No. EC120-31-010

# SERVICE BULLETIN

#### Interchangeability of the Vehicle Engine Management Display (VEMD)

Revision No.	Date of issue
Revision 0	2021-12-20

Figure 1

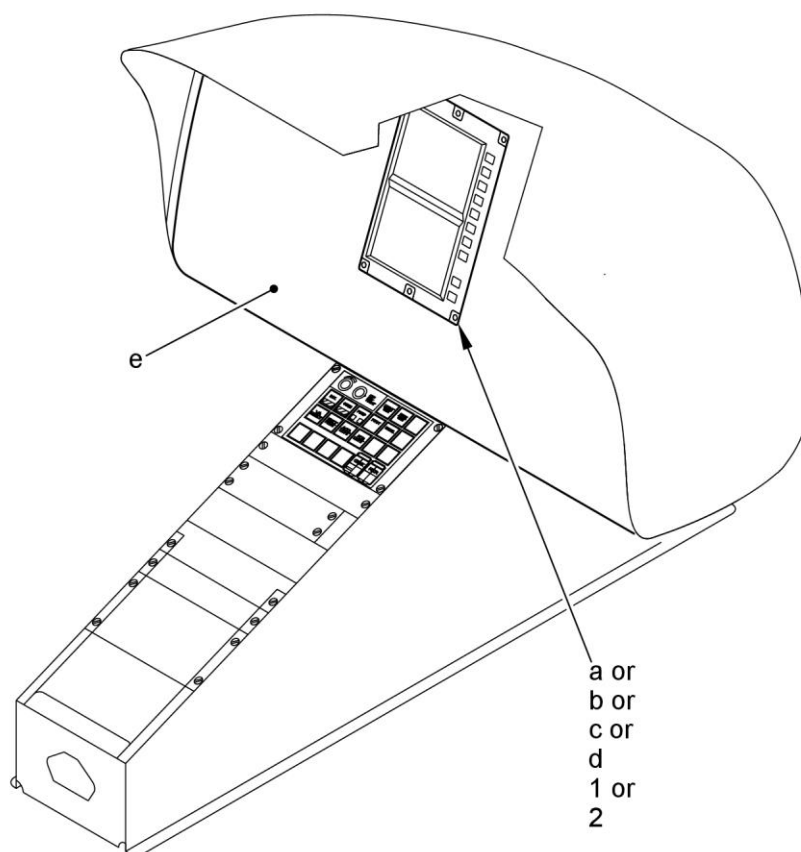
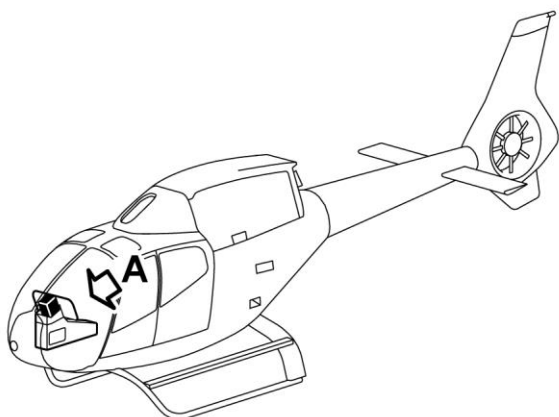
- Refer to Task 31-61-00, 4-1 (AMM) to remove one of the non-NVG VEMDs that follow from the instrument panel (e):
  - . MP/N B19030FB04 (P/N 7050A4316026) (a)
  - . MP/N B19030FC04 (P/N 7050A4316024) (b)
  - . MP/N B19030FB05 (P/N 7050A4316028) (c)
  - . MP/N B19030FC05 (P/N 7050A4316027) (d).
- Send the non-NVG VEMD (a) or (b) or (c) or (d) back to the manufacturer. Refer to paragraph [2.D](#).

- Make sure that the MP/N of the NVG VEMD (1) or (2) sent back by the manufacturer is:
  - . MP/N B19030WB04 (P/N 7050A4316025) (1)
  - . MP/N B19030WB05 (P/N 7050A4316029) (2).
- Do a test of the NVG VEMD (1) or (2). Refer to Task 31-61-00, 5-3 (AMM).
- Refer to Task 31-61-00, 4-1 (AMM):
  - . Install the VEMD (1) or (2).
  - . Do the configuration of the VEMD (1) or (2).
  - . Do the calibration of the VEMD (1) or (2).
